# Access Compliance Report

## Public Rights-of-Way

Intersection ID: 10029503	Main Street: KENSINGTON PALACE LN	Cross Street: N/A	Location: S
ADA ID: CD721A6E9E55	Ramp Type: Perp	Initial Pass/Fail: Fail	Overall Compliance: No
Severity Score: 48.75			
Codes/Mitigation Info/Possible Solution		Field Measurements/Component Compliance

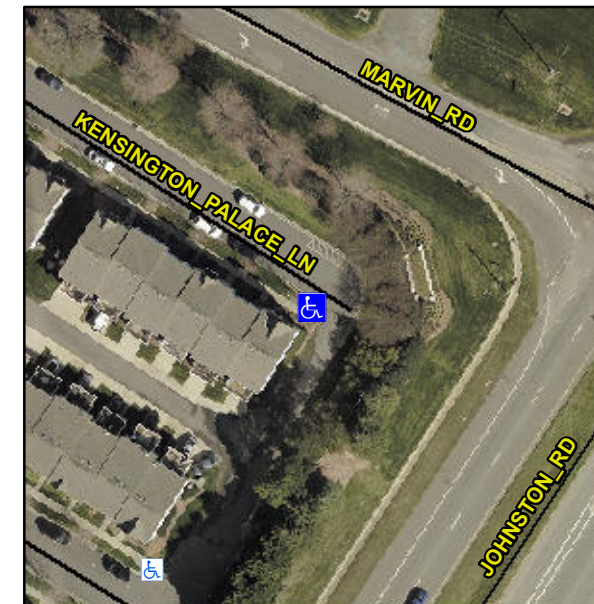
**R304.5.1, R304.2.2, R304.5.3**

Compliance	Description	Data	Compliance	Description	Data
N/A	Ramp Length (in)	48.0	No	Ramp Slope (%)	10.8
No	Ramp Width (in)	25.0	No	Ramp XSlope (%)	4.4
N/A	Flare Type LT	N/A	N/A	Flare Type RT	N/A
N/A	Flare Slope LT (%)	N/A	N/A	Flare Slope RT (%)	N/A
N/A	Flare Traversable LT?	N/A	N/A	Flare Traversable RT?	N/A
N/A	Landing Length (in)	N/A	N/A	DWS Provided?	N/A
N/A	Landing Width (in)	N/A	N/A	DWS Contrast?	N/A
N/A	Landing Slope (%)	N/A	N/A	DWS Length (in)	N/A
N/A	Landing X Slope (%)	N/A	N/A	DWS Full Width?	N/A
N/A	Landing Curb? (Y/N)	N/A	N/A	DWS Offset (in)	N/A
N/A	Shared Landing?	N/A			
N/A	Gutter Ponding?	N/A	N/A	Gutter Slope (%)	N/A
N/A	Gutter Lip Ht (in)	N/A	N/A	Gutter X Slope (%)	N/A
N/A	Painted X Walk1?	No	N/A	Painted X Walk2?	N/A
	X Walk 1 Direction	To NE		X Walk 2 Direction	N/A
N/A	X Walk 1 Width (in)	N/A	N/A	X Walk 2 Width (in)	N/A
	X Walk 1 Slope (%)	1.3		X Walk 2 Slope (%)	N/A
	X Walk 1 X Slope (%)	3.8		X Walk 2 X Slope (%)	N/A

**Remove & Replace Entire Ramp.**
